CITY PLANNING COMMISSION

PROPOSAL: The applicant is requesting the necessary entitlements to divide 2.3± vacant acres into 10 Single Family (R-1) lots.

P-83-413

TENTATIVE SUBDIVISION MAP
MEADOWLARK MANOR

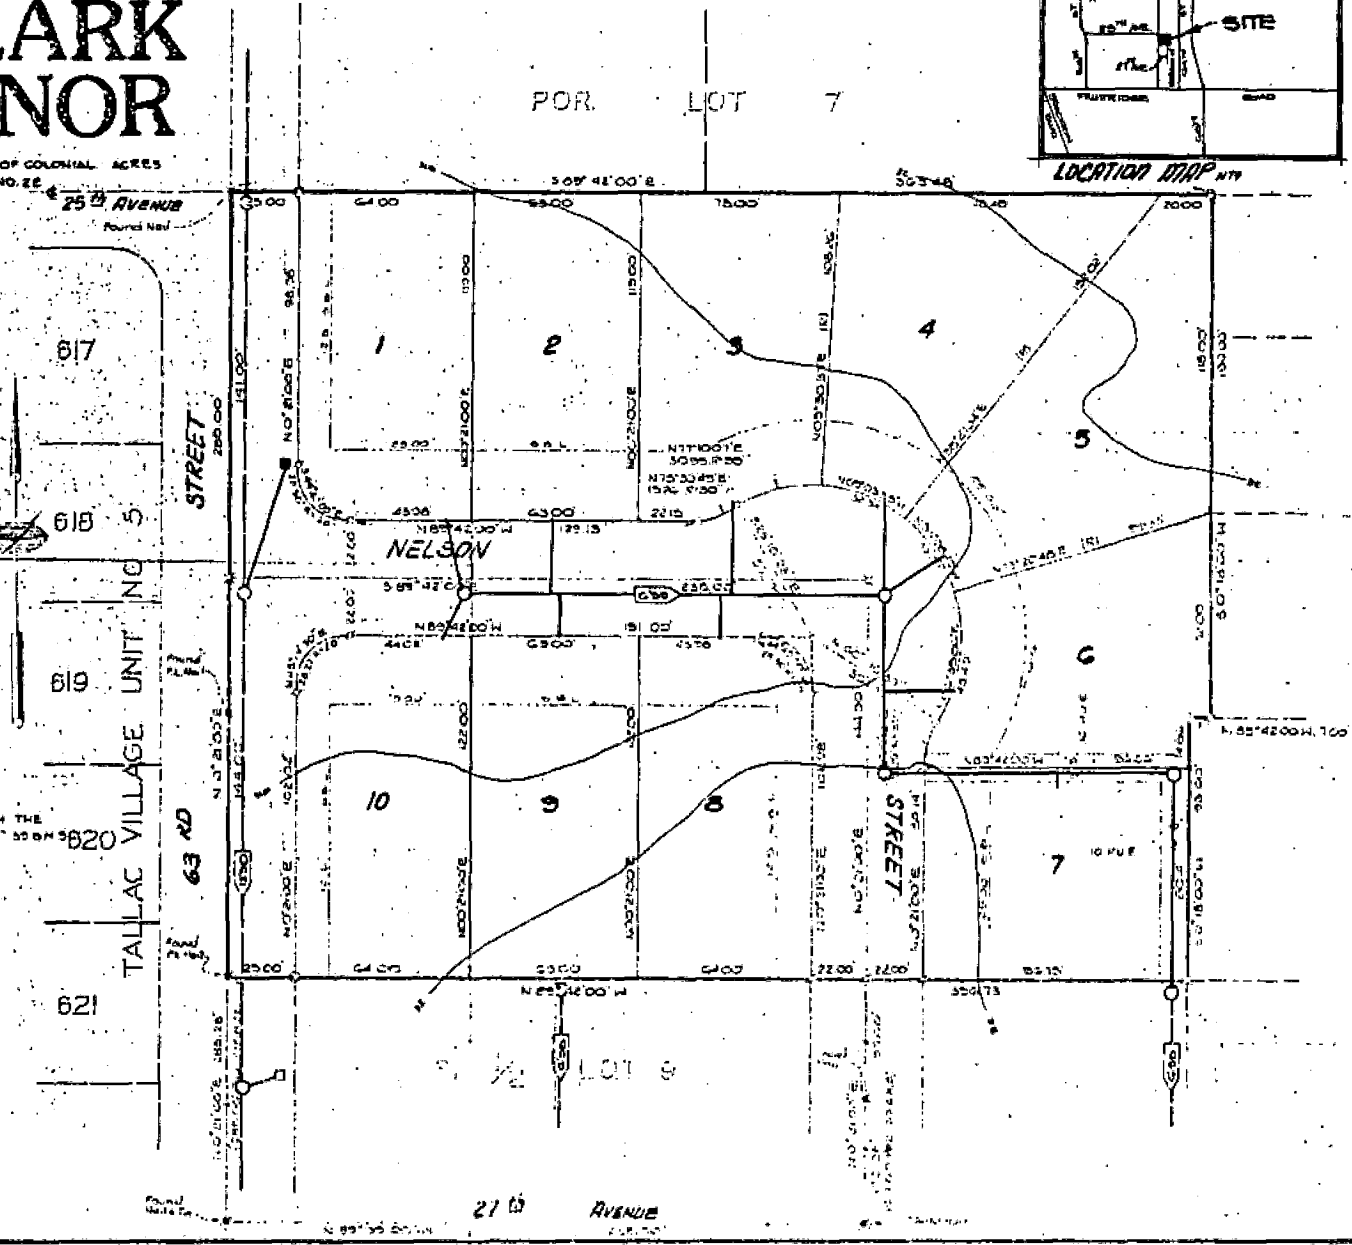
1. The subject site is located in an area developed with single family residences. It consists of two of the few remaining unsubdivided parcels in the area. Staff has no objection to the requested map. The proposed lots are compatible with the single family development in the area and with the R-1 zoning.

2. There is a variance/subdivision modification request to create two lots (Lots 6 and 7) less than 100 feet in depth. Staff has no objection to this request since it results from a slight irregularity in the shape of the parcel being subdivided. Furthermore, Nelson Street already stubs at the southern property line. Both lots will have adequate area for standard development without additional variance approvals.

1. Ratification of the Negative Declaration;
2. Approval of the Tentative Map, subject to the conditions which follow;
3. Approval of the Variance to create lots less than 100 feet in depth, based upon Findings of Fact which follow;
4. Approval of the Subdivision Modification to create lots less than 100 feet in depth.

- a. Provide standard subdivision improvements pursuant to Section 40.811 of the City Code;
- b. Prepare a sewer and drainage study for the review and approval of the City Engineers;
- c. Pursuant to City Code Section 40.1302 (Parkland Dedication), the applicant shall submit to the City an appraisal of the property to be subdivided and pay the required parkland dedication in-lieu fees. The appraisal shall be dated not more than 90 days prior to the filing of the final map.
